Responsiveness Summary
Sunflower Electric Power Corporation
Holcomb Expansion
Air Quality Construction Permit Application

Kansas Department of Health and Environment
Bureau of Air and Radiation
Air Permitting Section

October 17, 2007

Figure 9. Removal efficiency of three common particle removal technologies used on large stationary combustion systems. Reproduced by permission of IEA.¹⁴⁴

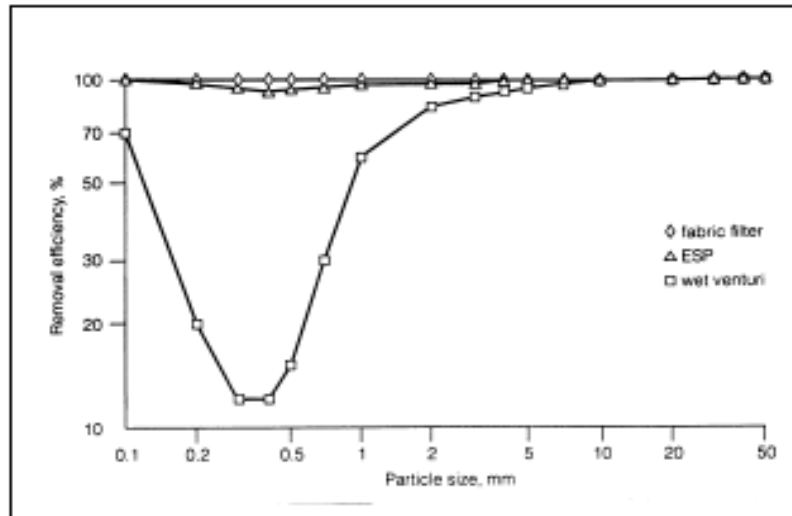
Lead is preferentially associated with the finer particulate matter. However, the commenter is incorrect in contending that a fabric filter is not effective in collecting such particles. For example, in SierraClub's Comments, (Exhibit 39, Figure 9,) clearly shows the relatively constant collection

efficiency of a fabric filter across a range of sizes, with good collection efficiency in the very smallest range of particle size. Figure 9 is shown below.
